OUR CHANGE PROPOSAL

Re: PCO 11 for **Electrical building code upgrades**

Project: Colchester Senior Center

Clarification(s): - Electrical Building code upgrades, changes to plans E101,E201,E202,E501 & E502

1 MAIN LEVEL LIGHTING PLAN
1/8" = 1'-0"

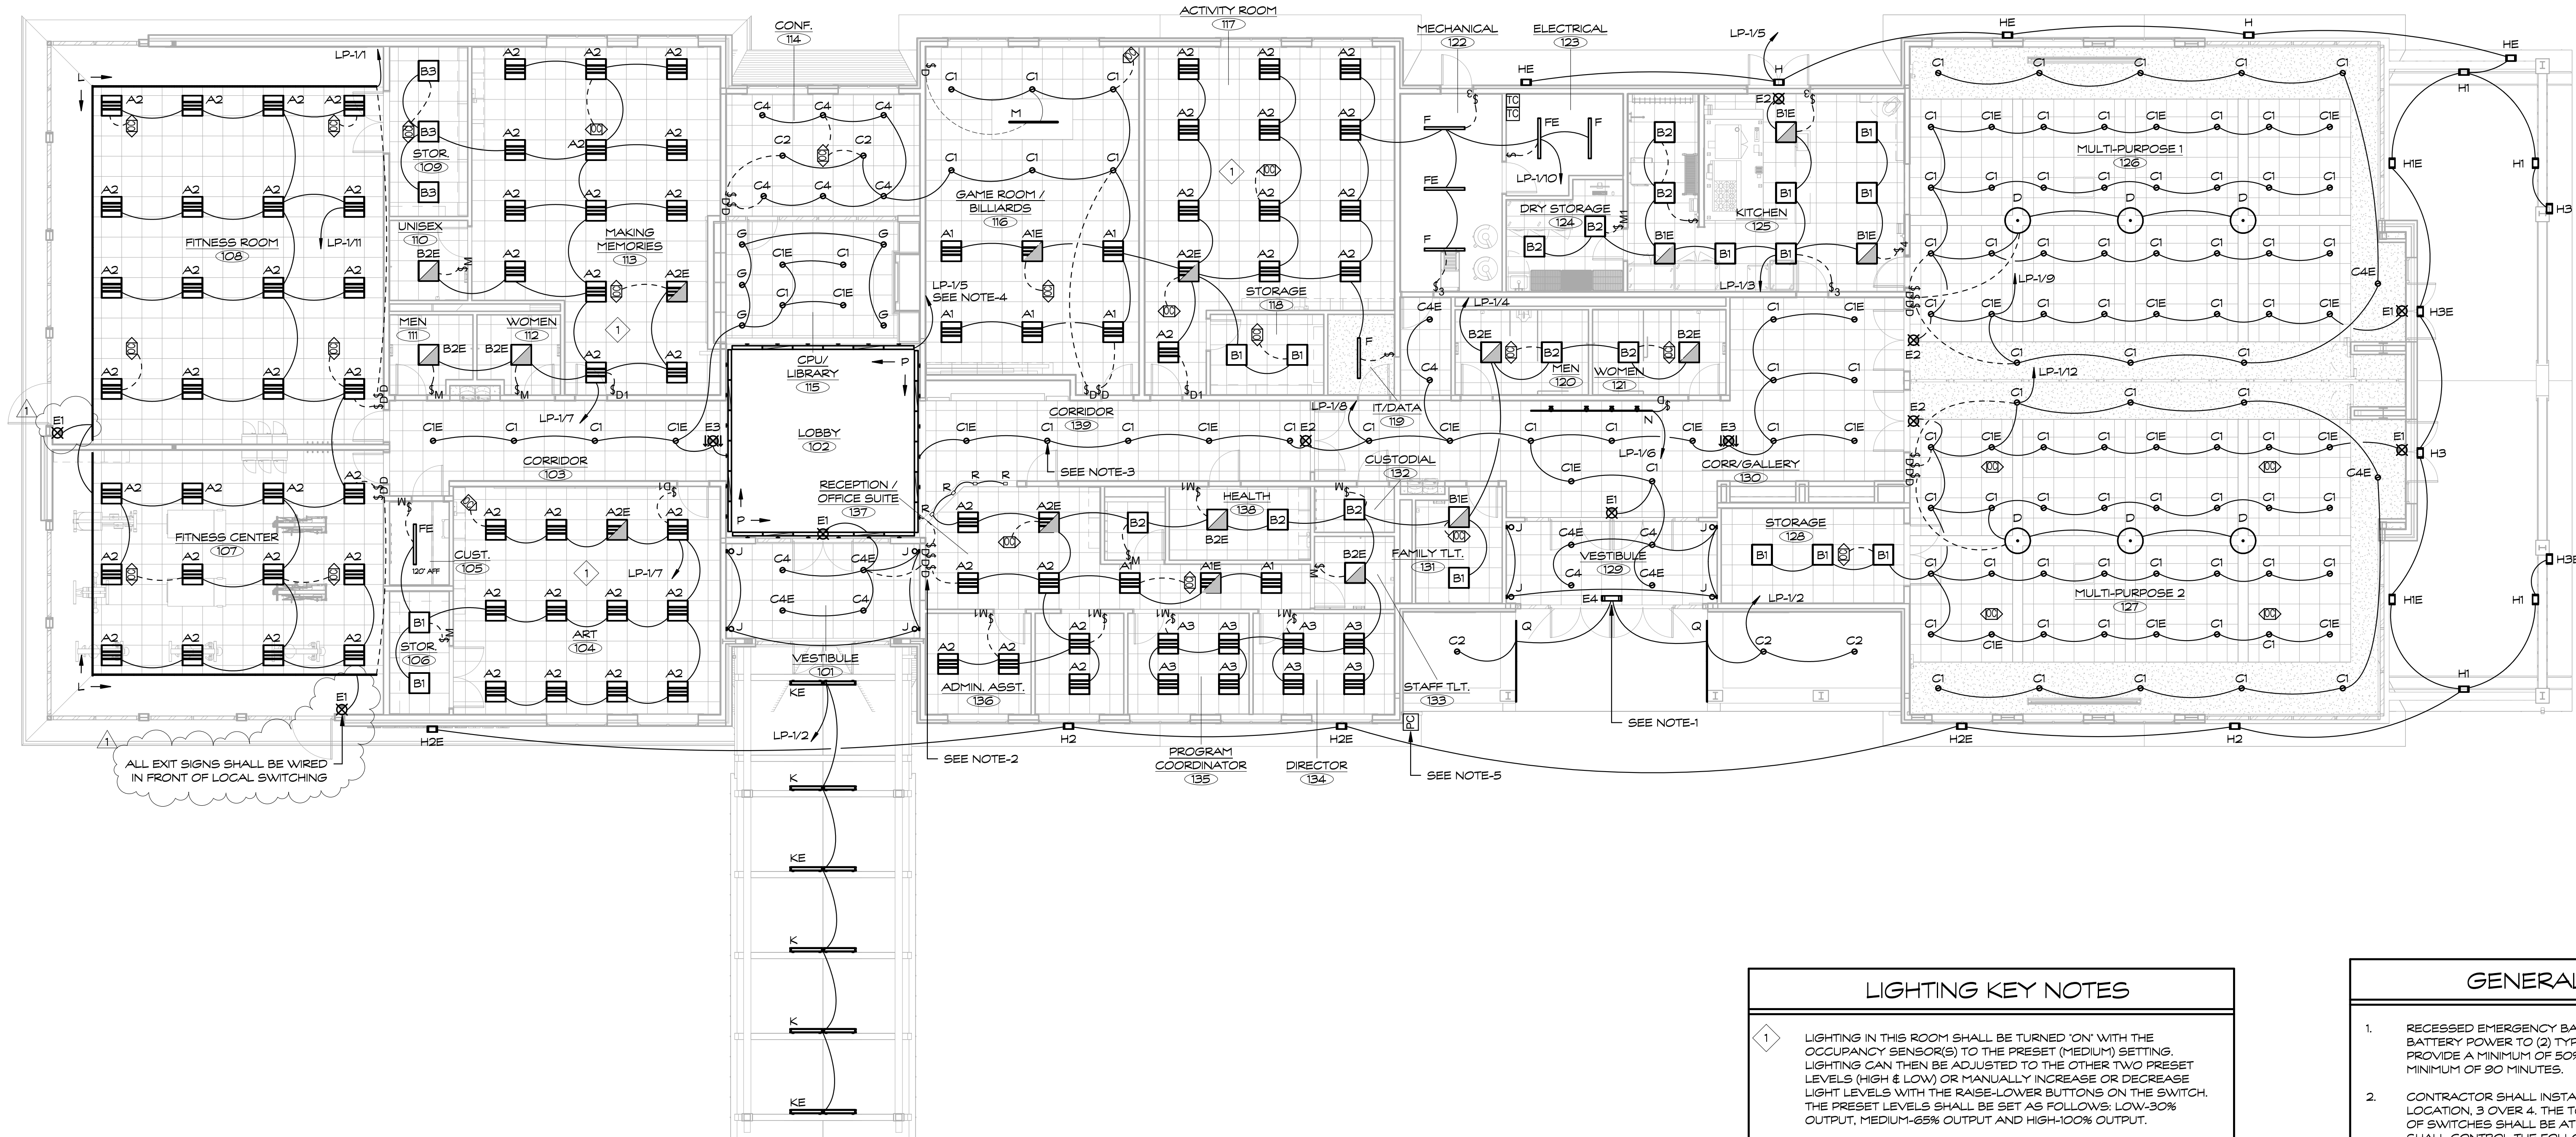
Revision:	Description:	Date:	Revised By:
1	ISSUED FOR BID	09/09/2022	
2	CODE REQUIREMENT	04/14/2023

1. LIGHTING IN THIS ROOM SHALL BE TURNED ON WITH THE OCCUPANCY SENSOR(S) TO THE PRESET (MEDIUM) SETTING. LIGHTING CAN THEN BE ADJUSTED TO THE OTHER TWO PRESET LEVELS (HIGH & LOW) OR MANUALLY INCREASE OR DECREASE LIGHT LEVELS WITH THE RAISE-LOWER BUTTONS ON THE SWITCH. THE PRESET LEVELS SHALL BE SET AS FOLLOWS: LOW-30% OUTPUT, MEDIUM-65% OUTPUT AND HIGH-100% OUTPUT.

1 MAIN LEVEL POWER PLAN
1/8" = 1'-0"

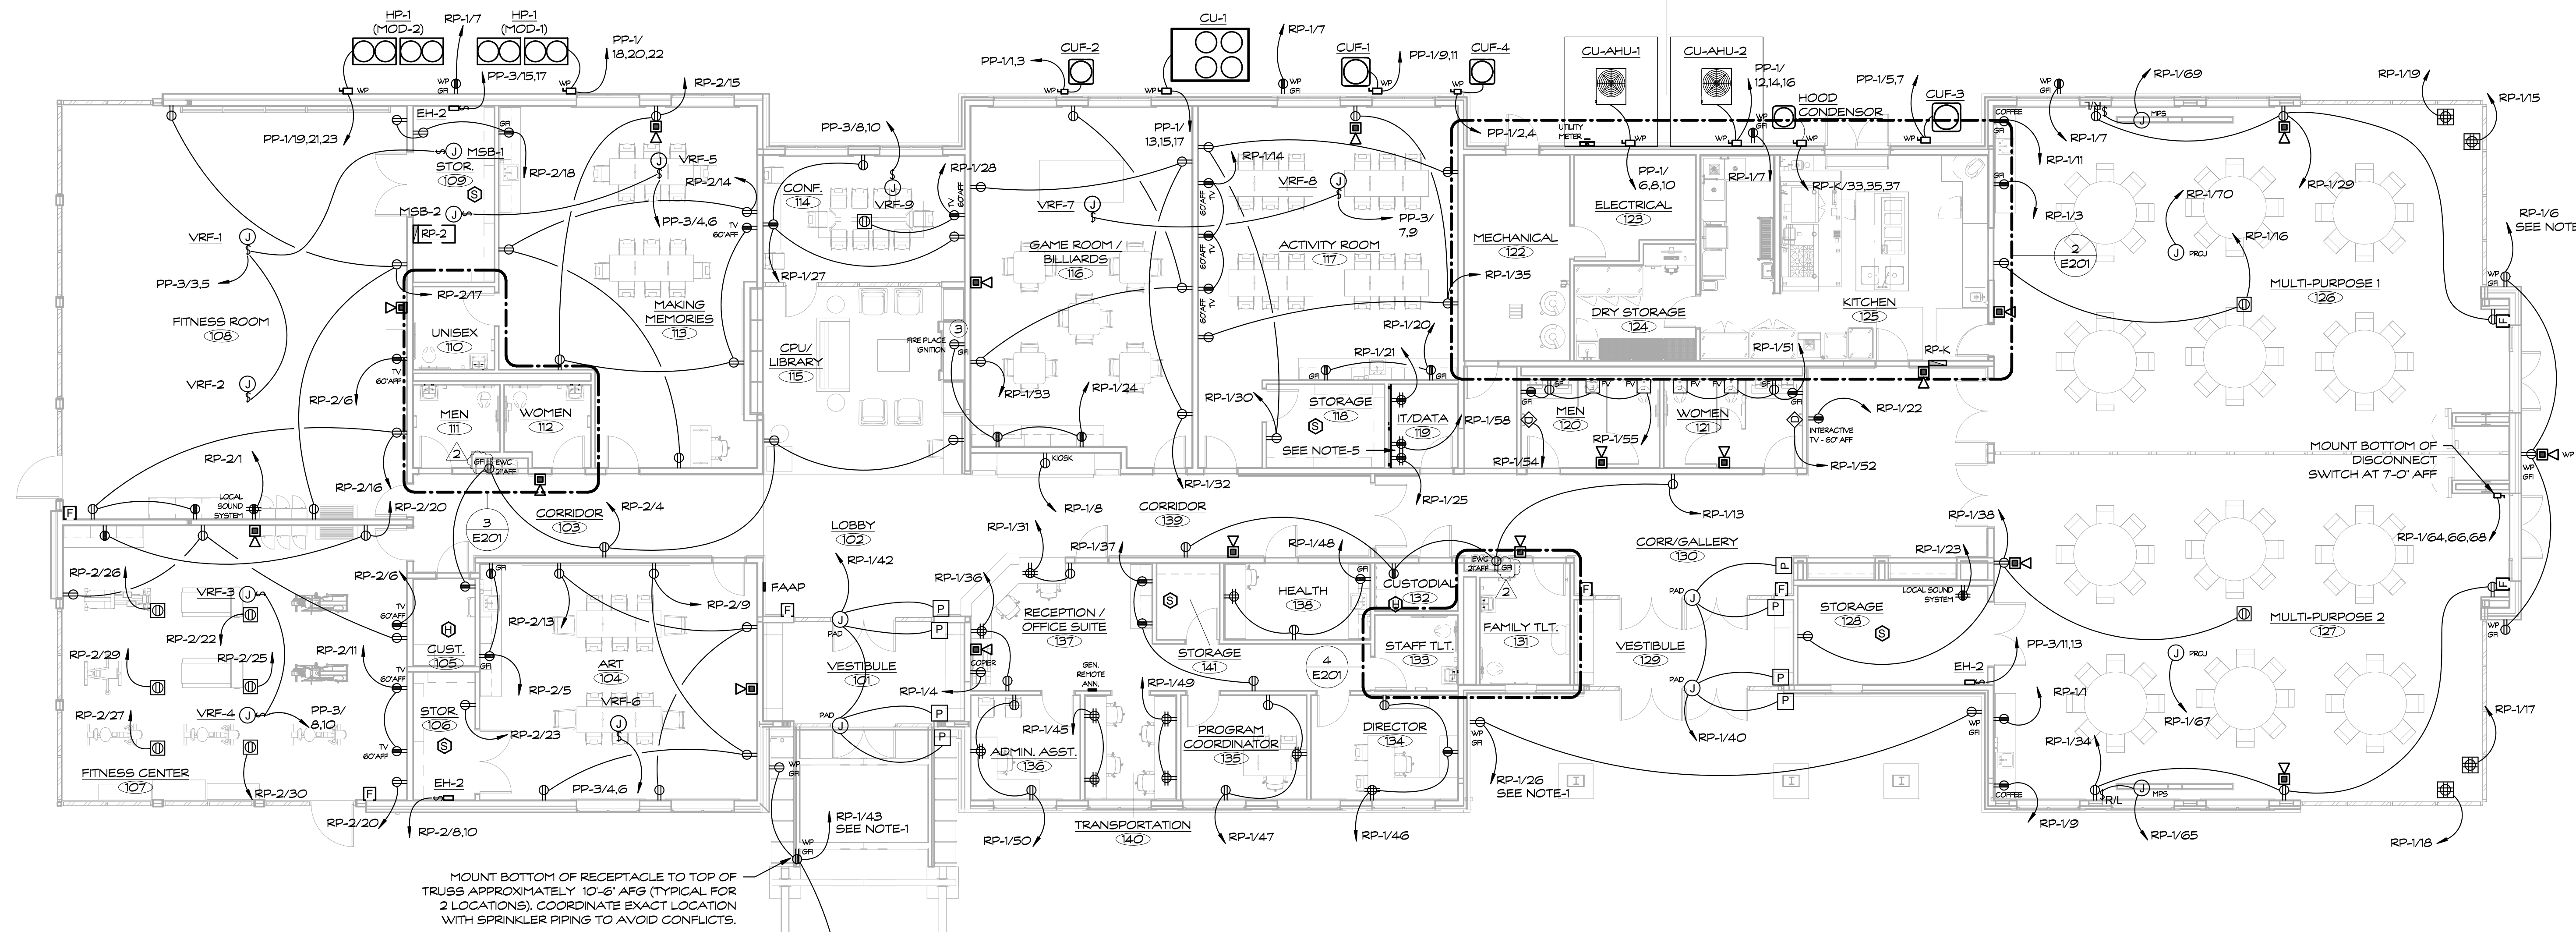
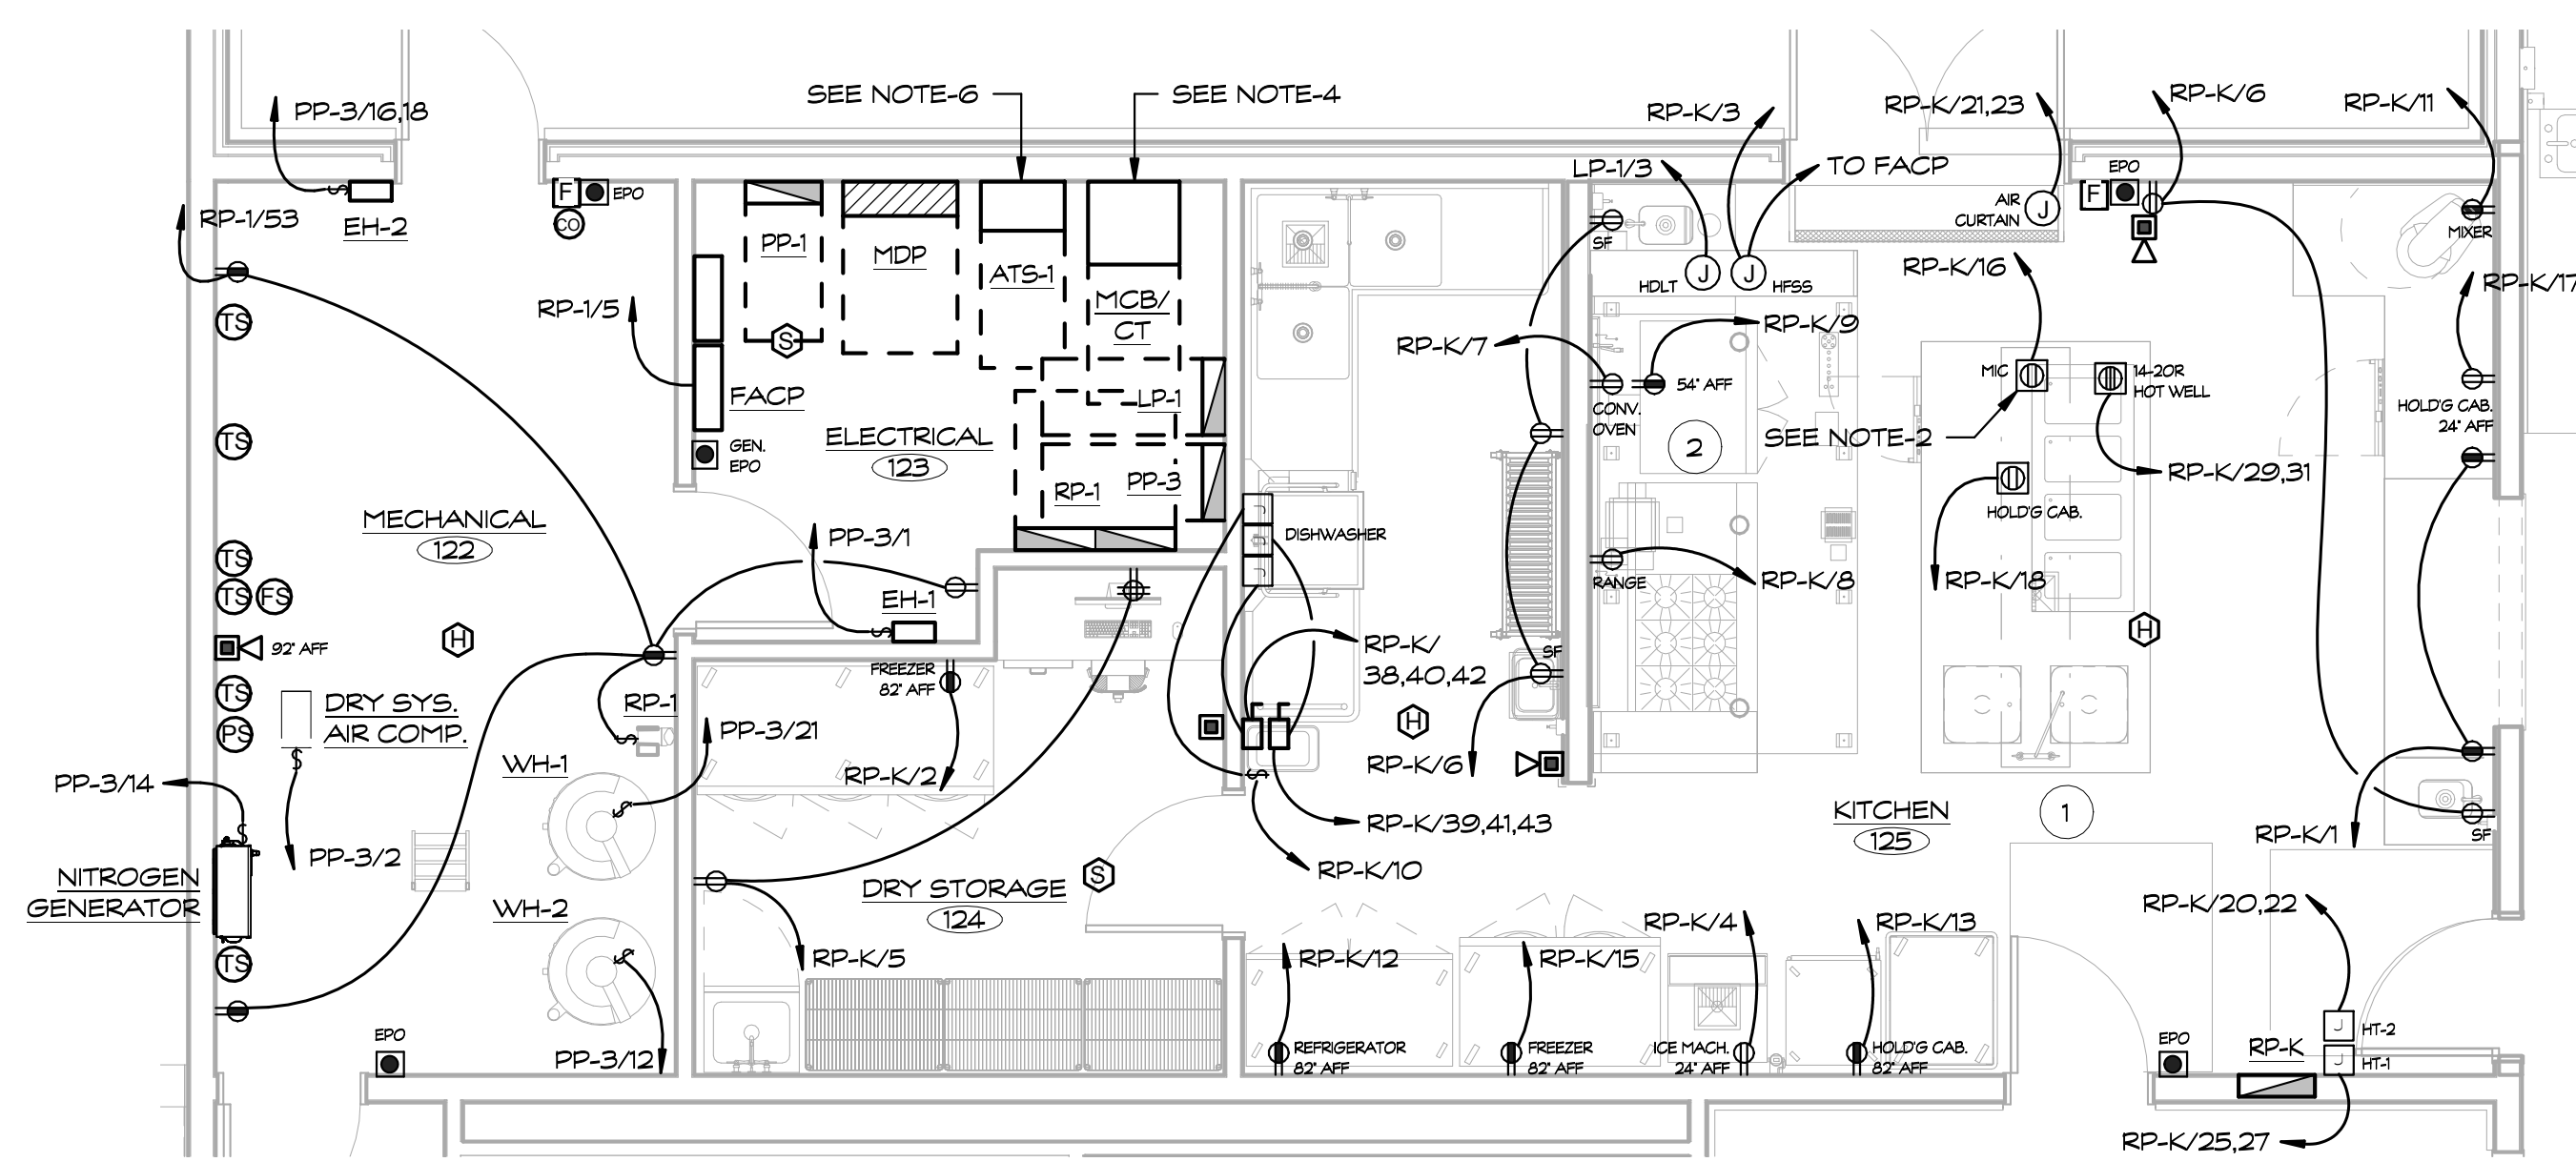
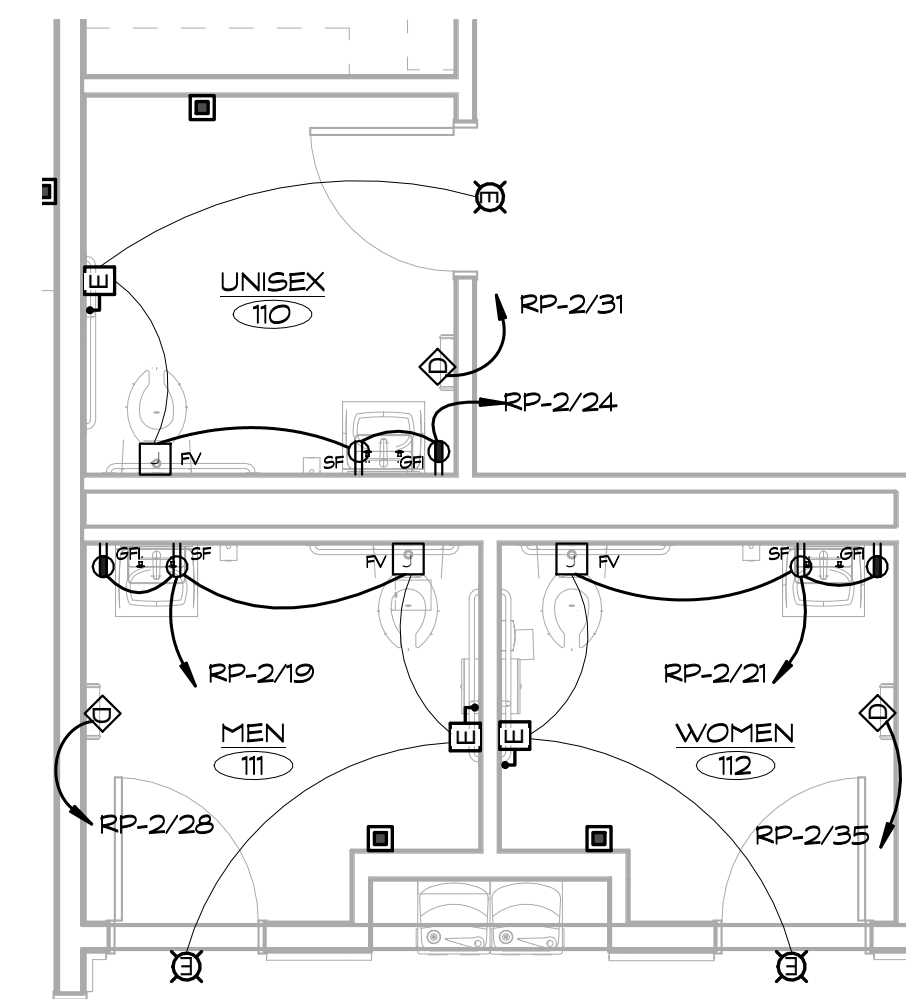
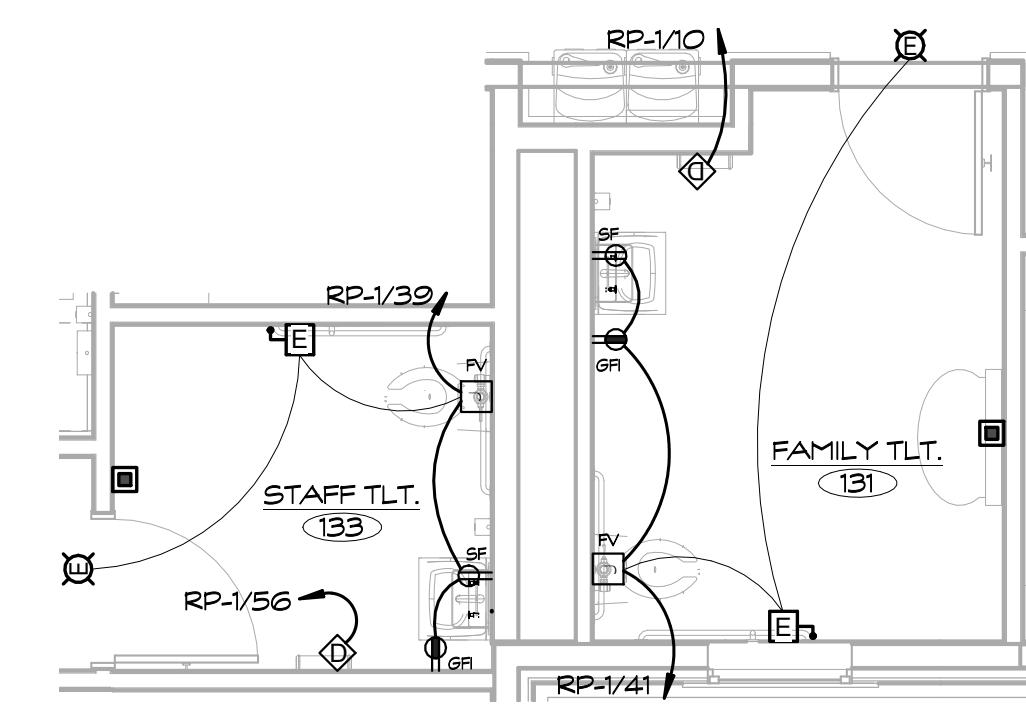
Revision:	Description:	Date:	Revised By:
1	ISSUED FOR BID	09/09/2022	
2	ADDENDUM 2	10/06/2022	
3	CODE REQUIREMENT	04/14/2023

- ### ELECTRICAL POWER KEY NOTES
- ALL SINGLE PHASE RECEPTACLES RATED 150 VOLTS TO GROUND OR LESS AT 50 AMPS OR LESS AND THREE PHASE RECEPTACLES RATED 150 VOLTS TO GROUND OR LESS AT 100 AMPS OR LESS INSTALLED IN THE KITCHEN SHALL HAVE GROUND FAULT CIRCUIT INTERRUPTER PROTECTION PER NEC 210.8-B. ALL DEVICES LOCATED UNDER THE KITCHEN HOOD SHALL BE FED FROM A GFCI BREAKER INSTEAD OF THE DEVICE TO ALLOW THE ABILITY TO RESET A TRIPPED CIRCUIT. ALL WALL MOUNTED RECEPTACLES IN THE KITCHEN SHALL BE MOUNTED HORIZONTALLY. IN ADDITION TO GFCI PROTECTION, ALL RECEPTACLES IN THE KITCHEN/DISHWASH AREA ARE ALSO TO BE WEATHER-RESISTANT TYPE DEVICES.

- ALL RECEPTACLES IN THE KITCHEN THAT REQUIRE GFCI PROTECTION THAT SERVE EQUIPMENT THAT CAN NOT BE EASILY MOVED TO RESET THE TRIP SHALL BE SERVED BY A GFCI PROTECTED BREAKER NOT A RECEPTACLE.

- ALL RECEPTACLES LOCATED IN 'WET AND DAMP' LOCATIONS NEED TO BE WEATHER-RESISTANT TYPE PER NEC.
 - IN ADDITION TO REQUIREMENTS IN SPECIFICATION SECTION 260553, ALL DISCONNECT SWITCHES SHALL BE LABELED CLEARLY WITH THE EQUIPMENT THEY SERVE (AHU-1, P-1, ETC.) AND THE BRANCH CIRCUIT THAT SERVES THE SWITCH (RP-K/39,40,42, RP-2/6, ETC.).
